**TECHNICAL SERVICE BULLETIN #501**

**Subject: Recall for 24V-637 Landing Gear Support Brace Mount Welds**

## IMPORTANT SAFETY RECALL NHTSA Recall No. 24V-637

## LG Rework Instructions

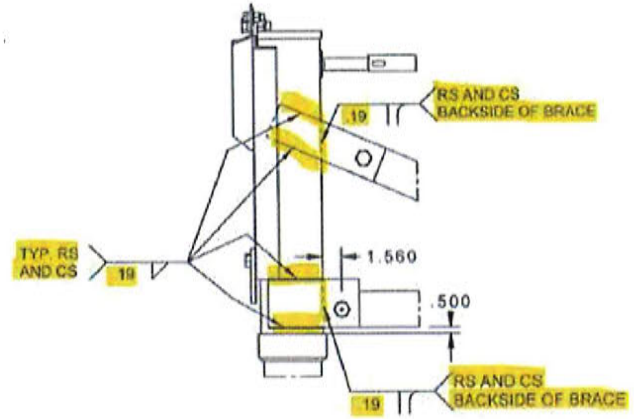
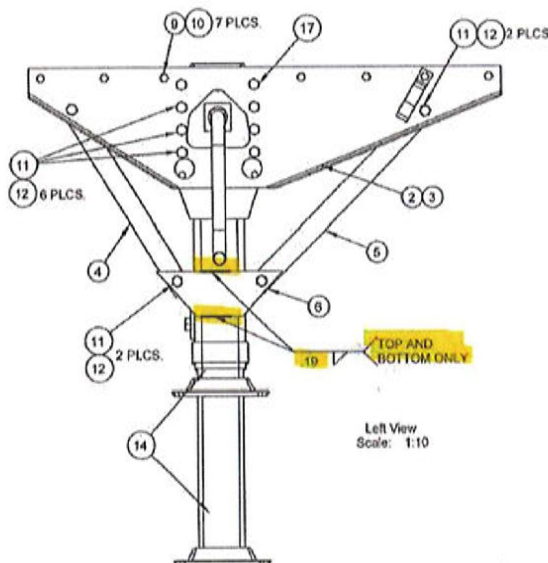
A visual inspection of welds may be performed by a trained welder with proper inspection tools to recognize correct weld leg length and weld size. (oversize welds will be acceptable, leg centerline lengths that are not equal will not be)

- Recommend .19 Single-J Groove weld be applied on back side of LG ears to provide additional reinforcement.
- Drawing 10309047018 Detail Excerpts
- PDF AWS D1.1 Standards Fillet Weld to Plate Thickness

- Trailer LG trapezoid/tab welds will be inspected, determination made as to LG weld integrity.
- Trailer brakes set; support jacks placed.
- Suspect welds will have a groove made the length of the current weld on the trapezoid/tab side.
- .25 fillet weld performed in prepared site ensuring proper fusion and tie-in of old weld.
